**TOWN OF NEWBURGH
PLANNING BOARD
TECHNICAL REVIEW COMMENTS**

PROJECT NAME: HILLSIDE LAND DEVELOPMENT
PROJECT NO.: 22-27
PROJECT LOCATION: SECTION 34, BLOCK 2, LOT 66/24 JEANNE DRIVE
REVIEW DATE: 9 JUNE 2023
MEETING DATE: 15 JUNE 2023
PROJECT REPRESENTATIVE: FELLENER ENGINEERING, LLP

Subject: Hillside Land Development #2022-27
Jeanne Drive, Newburgh, NY
Fellenzer Engineering Project 19-049

Please find attached proposed site plans in regards to the above referenced project. We have received the MHE technical review comments dated 04/28/23 and offer the following responses in italics below:

1 SITE PLAN
1"=30'

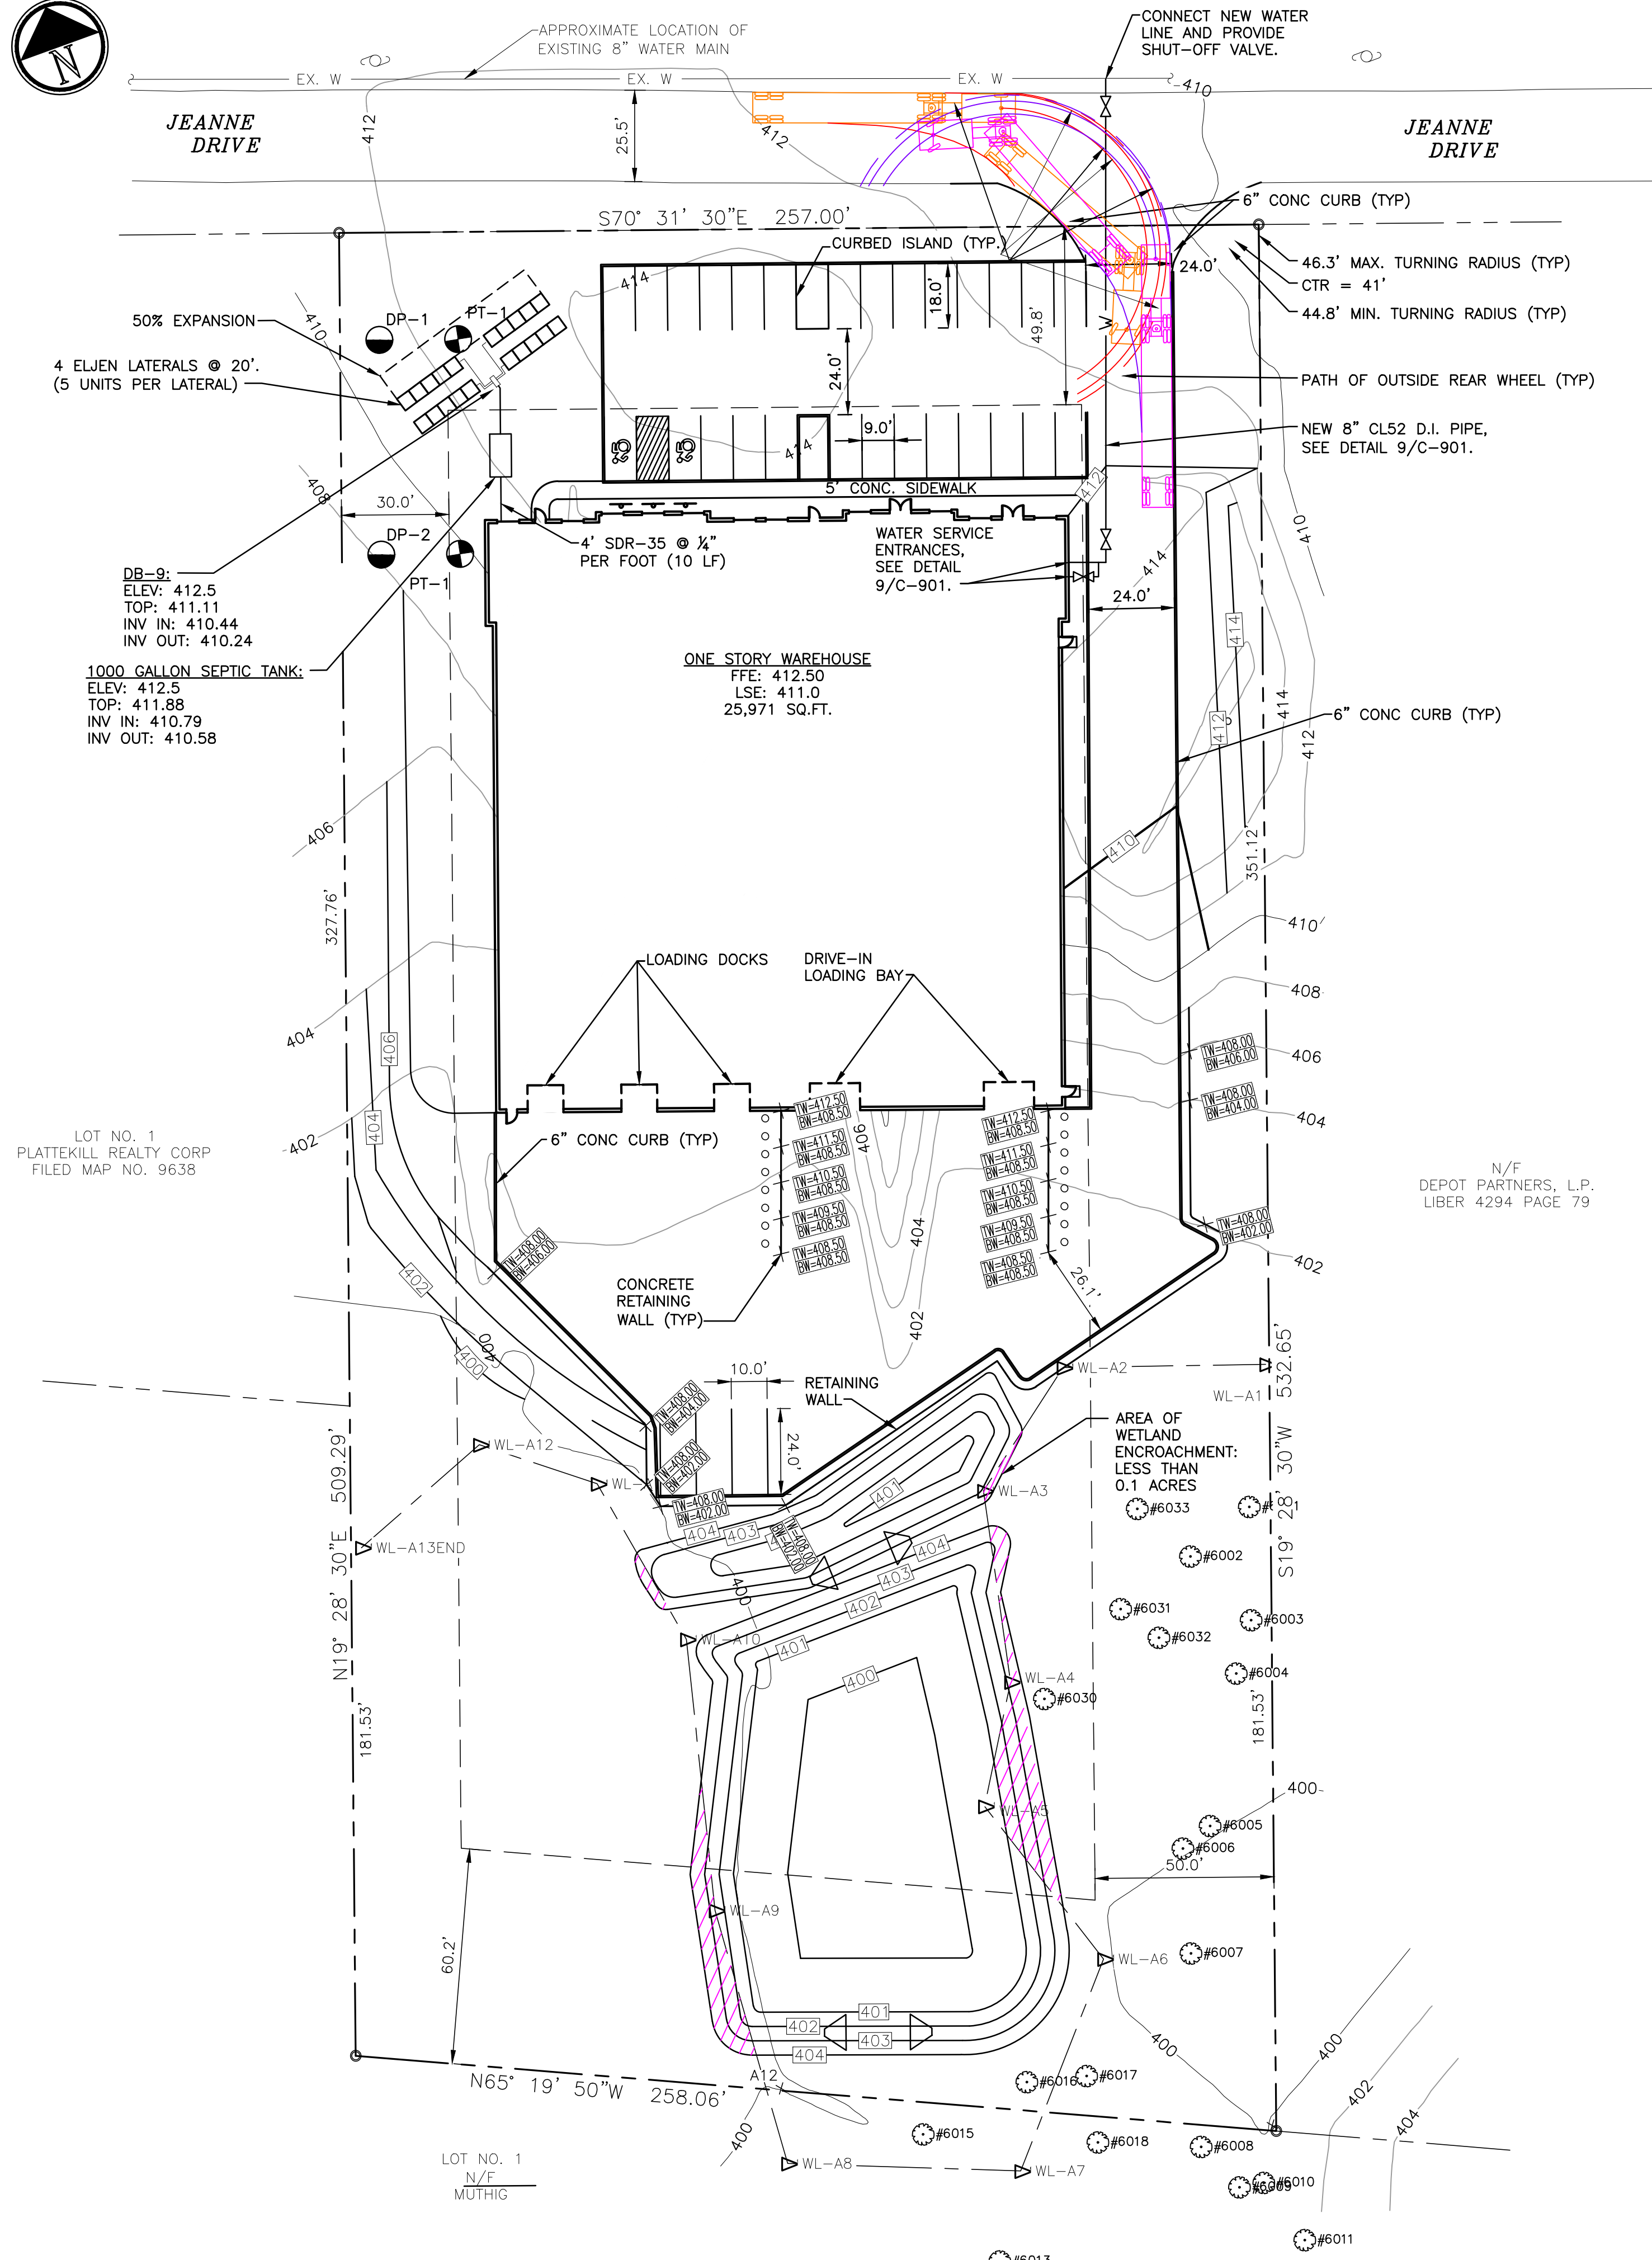
3. The location of the percolation and deep test should be depicted on the plan sheet.

4. The applicant's representatives are requested to confirm that all parking areas are to be curbed. Curbing should be called out on the plans. The applicant's representative is requested to evaluate the use of curb inlet catch basins along the curb lines.

11. The water service valving for the project site should be per the Town Standard Detail, copy attached. The detail requires potable water to be terminated if fire protection water is terminated.

FE Response: The locations for the percolation and deep tests are now shown on sheet C-101.

FE Response: The site plan has been labeled to show curbing around the entire paved area and the catch basins have been updated to curb inlet catch basins.

FE Response: The water service valving and connection now matches the Town Standard Detail as shown on sheet C-101 and the Town Standard Detail is now shown on sheet C901.

FE Response: The plans now show on sheet C-101 a right hand turn off of Jeanne Drive into the driveway.

1 LANDSCAPING PLAN & EROSION & SEDIMENT CONTROL PLAN

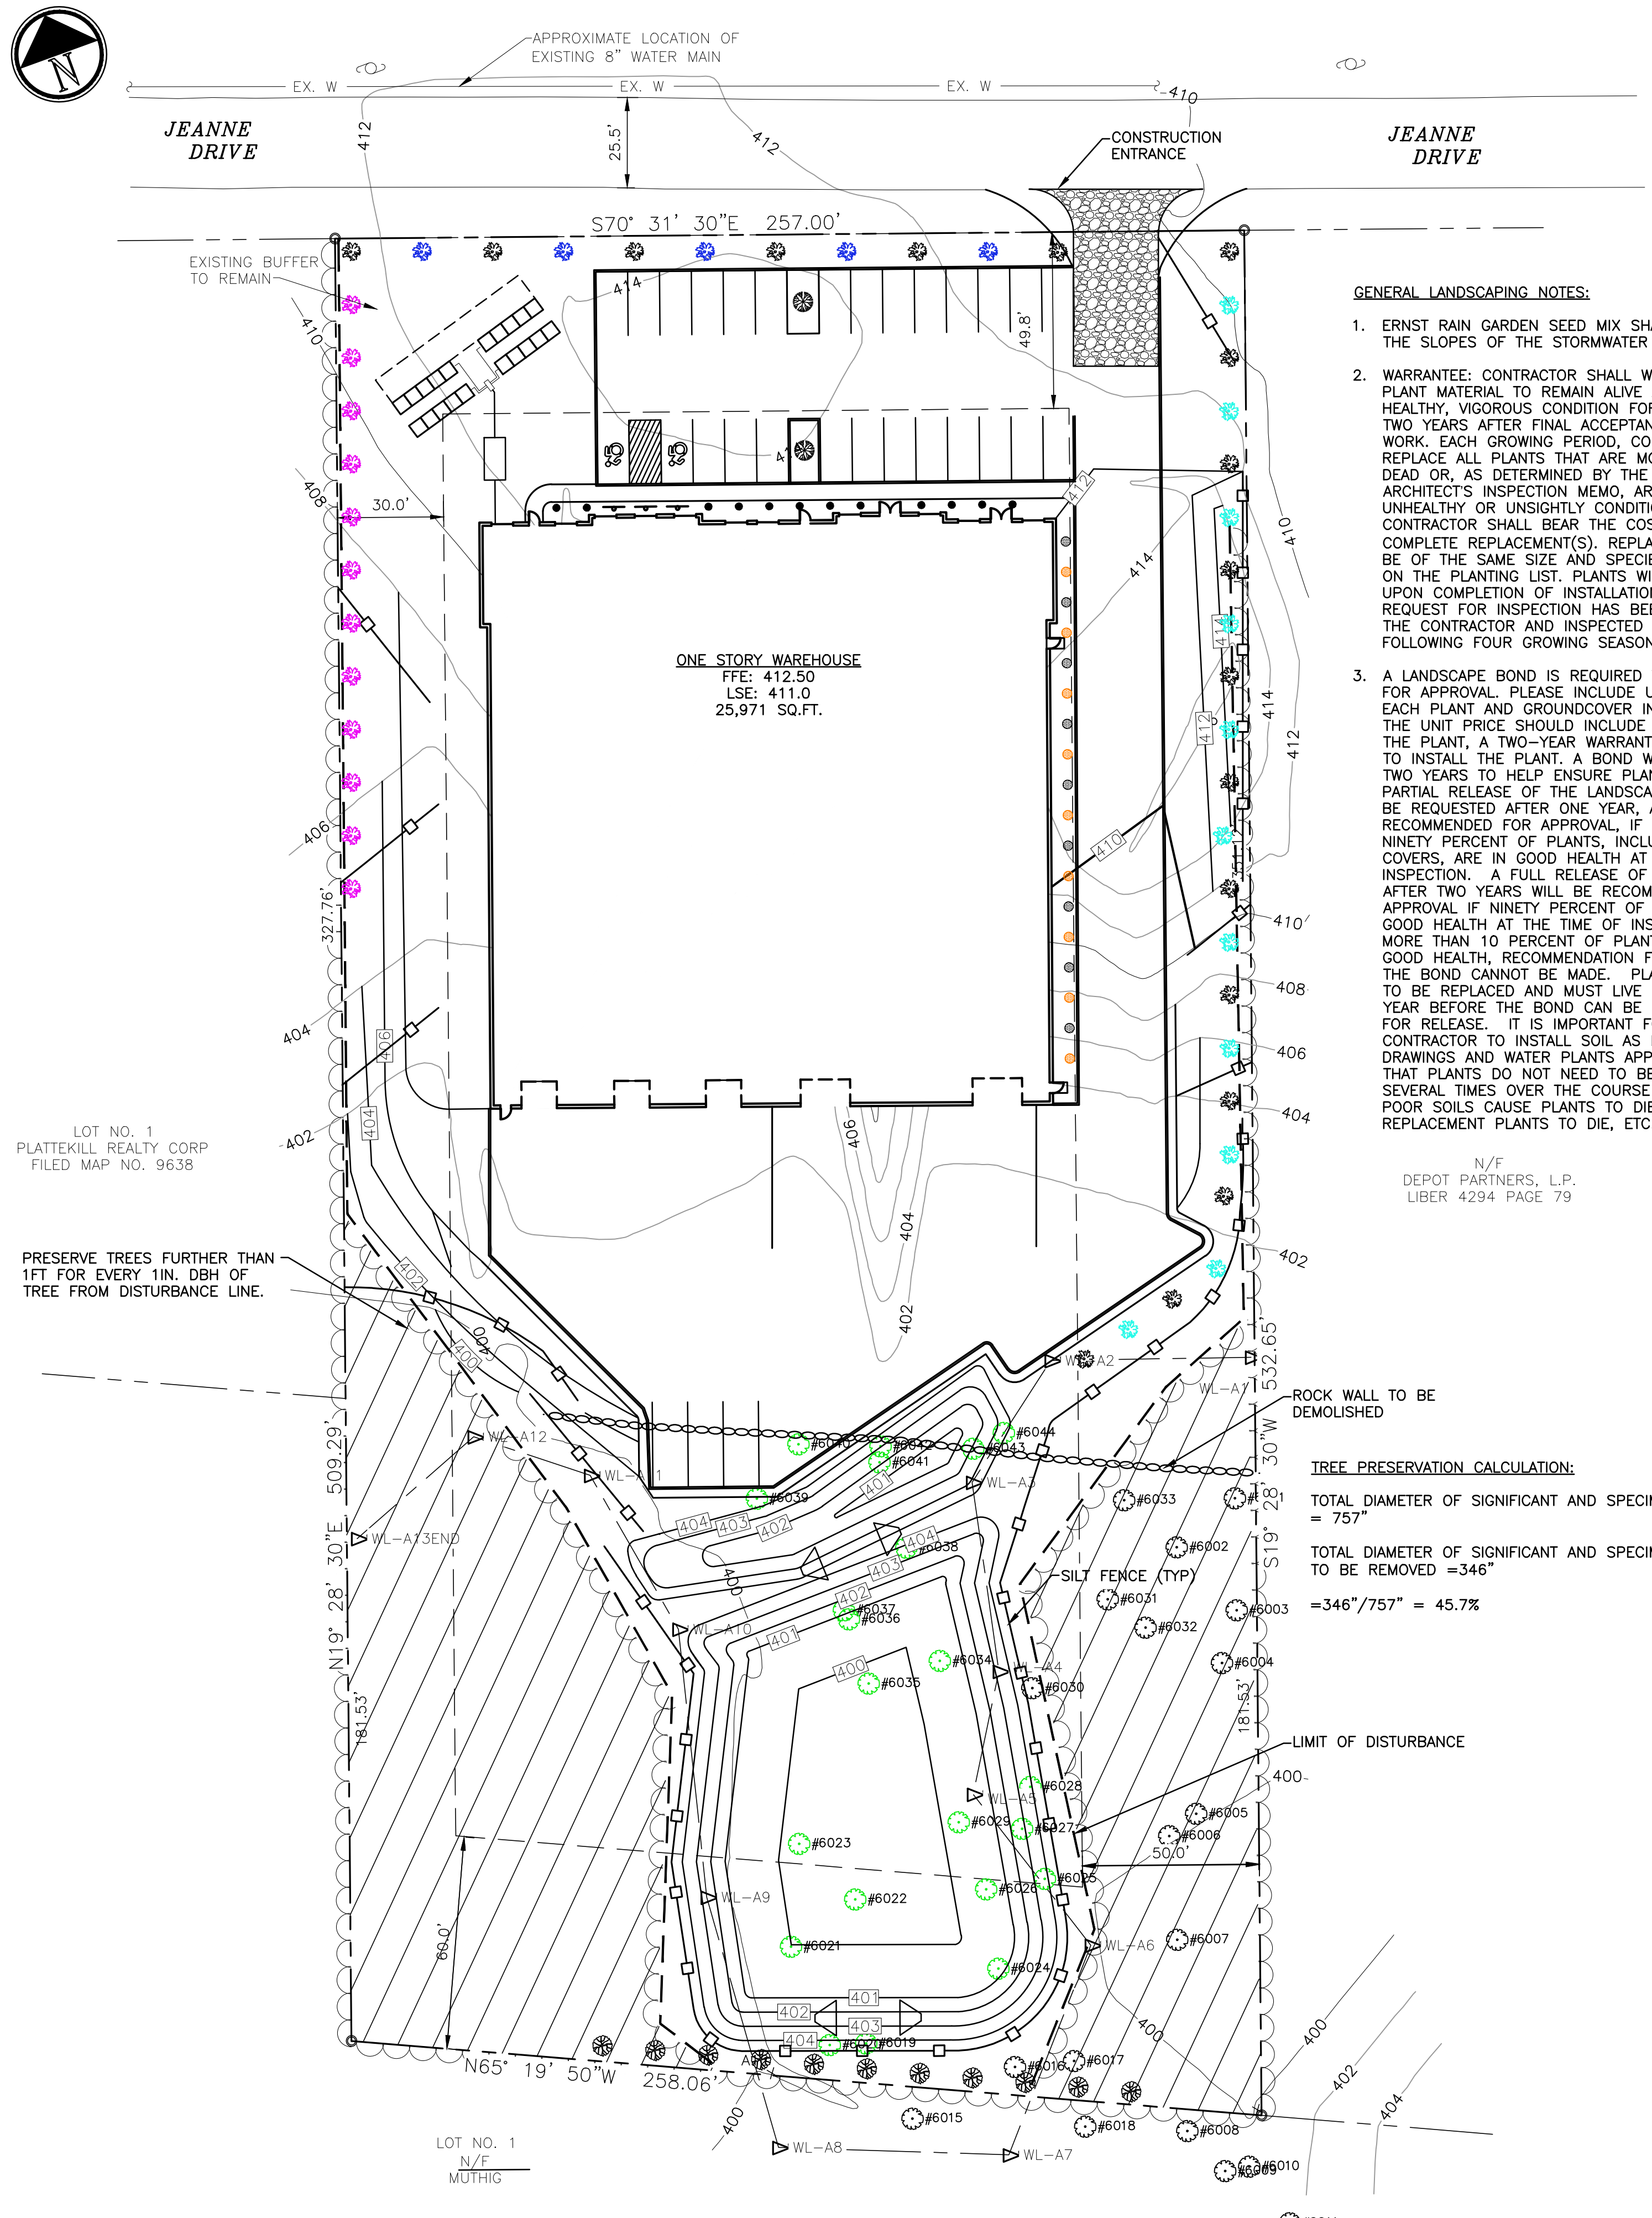
9. The Tree Preservation Plan is not colorized based on existing trees to be removed. It is recommended that a report and calculation consistent with Chapter 172 of the Town Law be provided.

1. To shade the parking lot, show shade trees along the west side of the proposed parking lot in front of the proposed warehouse. To avoid interfering with the proposed septic field, choose a tree with a taproot such as *Nyssa Sylvatica* (Black Tupelo).

2. American Holly is not an acceptable parking lot tree. The objective of trees in a parking lot is to provide shade. An evergreen does not provide as much shade in a parking lot as a shade tree would. Instead propose a shade tree such as Princeton American Elm.

5. To add some ecological variety to proposed trees on site, change approximately half of the proposed Red Maples to Pin Oaks.

6. If only street trees are proposed along Jeanne Road, add one Eastern Redbud between each proposed shade tree to add a variety of heigh, color, and interest along the road, and to provide some additional screening.

FE Response: The calculation in accordance for the Tree Preservation Law is shown on sheet C-701.

FE Response: On sheet C-701 the trees that will be removed have been colorized in accordance to Chapter 172 of the Town Law.

FE Response: Shade trees (Nyssa Sylvatica) have been added along west side of the building along the property line.

FE Response: Princeton American Elm have been added to the curbed islands in the parking lot instead of American Holly.

FE Response: Along the east property line half of the Red Maples have been changed to Pin Oaks.

FE Response: Along Jeanne Drive, Eastern Redbud has been put in between each Red Maple.

9 TOWN OF NEWBURGH FIRE PROTECTION FLOW TO BLDG. CONNECTION DETAIL
N.T.S.

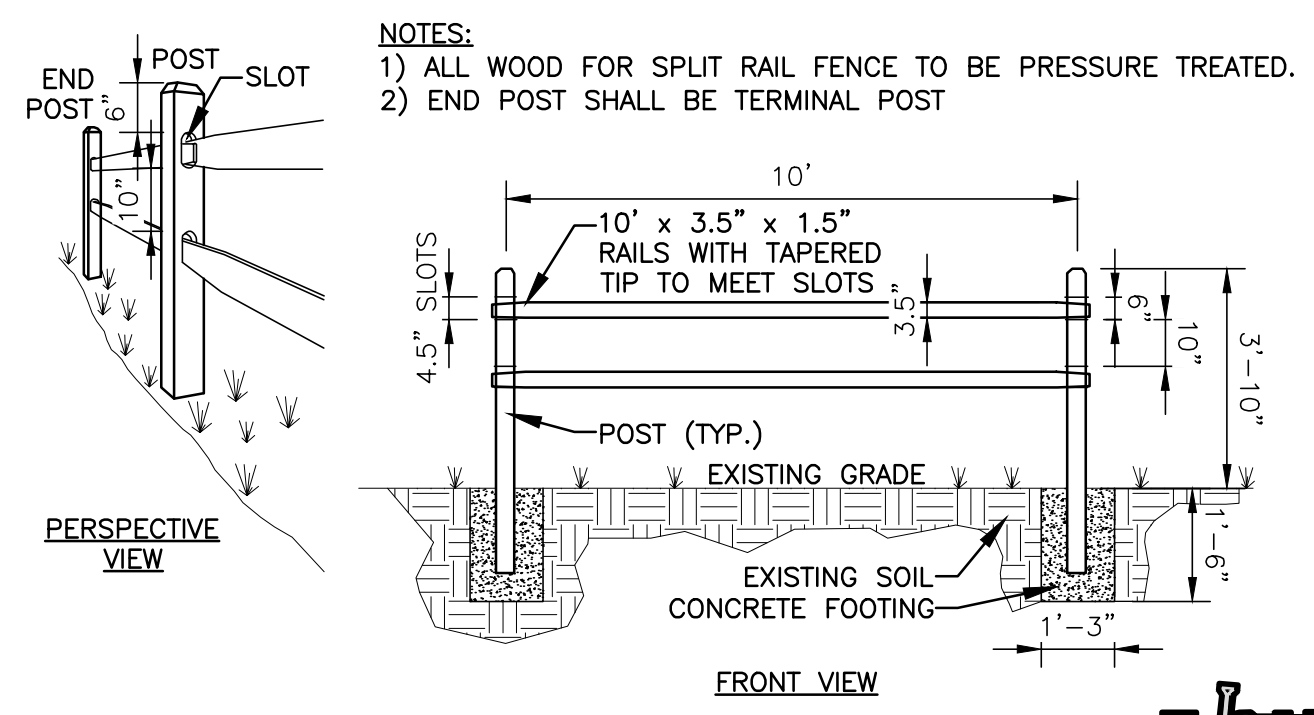
12. An 8 inch Class 52 ductile liner pipe is depicted entering the site. The size of the potable and fire flow connections should be identified on the detail.

FE Response: The size of the potable and fire flow connections are label on the detail on sheet C-901.
